DART AEROSPACE LTD		Work Order:	23762
Description: Spacer Block Kit		Part Number:	D206-667-011
RF 04.03.22			
Dwg: D3193 Rev. B, DSI 9263 Rev. A		Qty:	8 Kit(s)
BI		Page 1 of 1

DESIGN	CP	DRAWN BY	CP	DART AEROSPACE LTD HAWKESBURY, ONTARIO, CANADA	
CHECKED	#	APPROVED	#	DRAWING NO. D3193	REV. B SHEET 1 OF 1
DATE	03.12.22			TITLE SUPPORT BRACKET ASSEMBLY	SCALE 1:2
A	03.06.09			NEW ISSUE	
B	03.12.22			MANUFACTURED BY DART	
BI	# # 04.03.22			MS20426AD3-8 WAS MS20426AD3-5

D3193-041 SUPPORT BRACKET ASSEMBLY (D3193-1 SUPPORT BRACKET)

From: David Shepherd [davids@dartaero.com]
Sent: Monday, September 26, 2005 1:28 PM
To: Roberto Fuentes
Subject: Re: D3193-041 rivet/ spacedoor

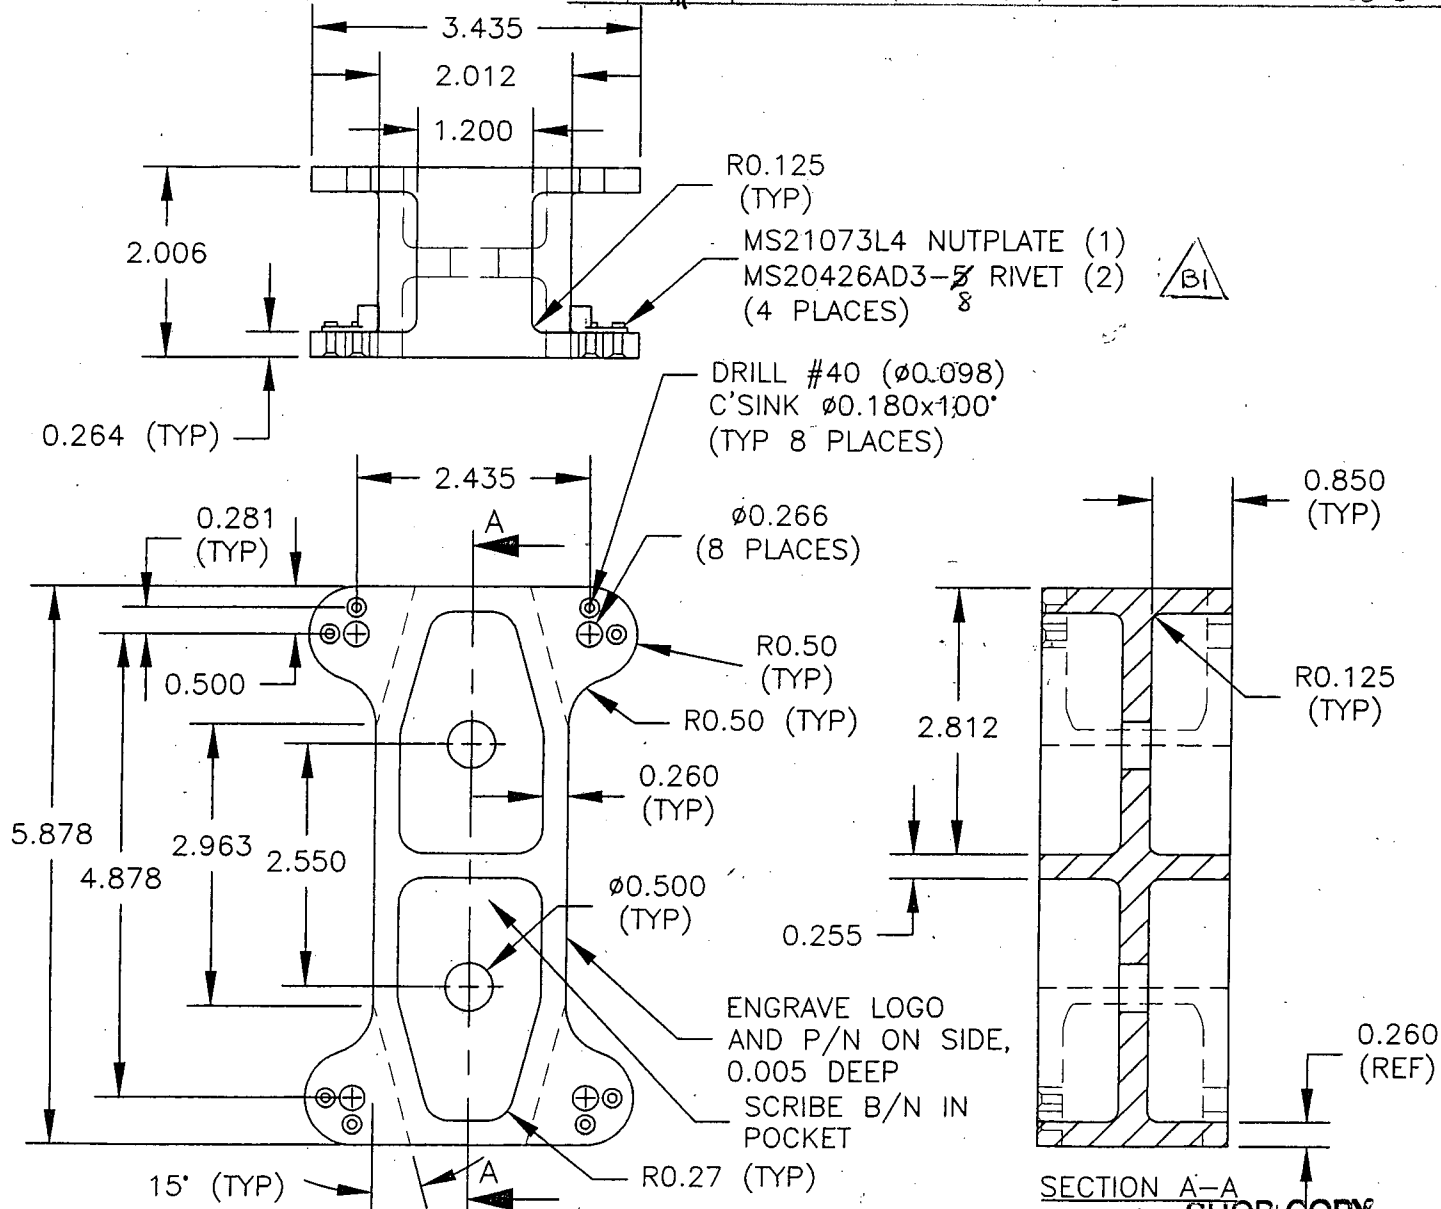
W/O:		WORK ORDER CHANGES					
DATE	STEP	PROCEDURE CHANGE	By	Date	Qty	Approval Mfg / Design Mgr	Approval QC Inspector
05-09-27	11	MS20426 AD3-8 rivet too long for assembly/ Always cracking & going crooked, changed rivet to A - 7 instead.	JB 05/09/27			JB 05.09.29	 05-09-27

1) D3193-041 bracket the ipp and dwg call for MS20426AD3-8 rivet very often crack because the only tool access to that area. They try with -7 rivet is better see picture but to get right dia of the mushroom is rivet of the left on -001, on right on the same picture is 0.02 less on dia of the mushroom. See picture call bracket 001 is -7 and 002 is -8 size. It is acceptable to change?

Both of these changes are acceptable to me. Please make sure the relevant drawings are updated accordingly. I can sign when I am there later this week.
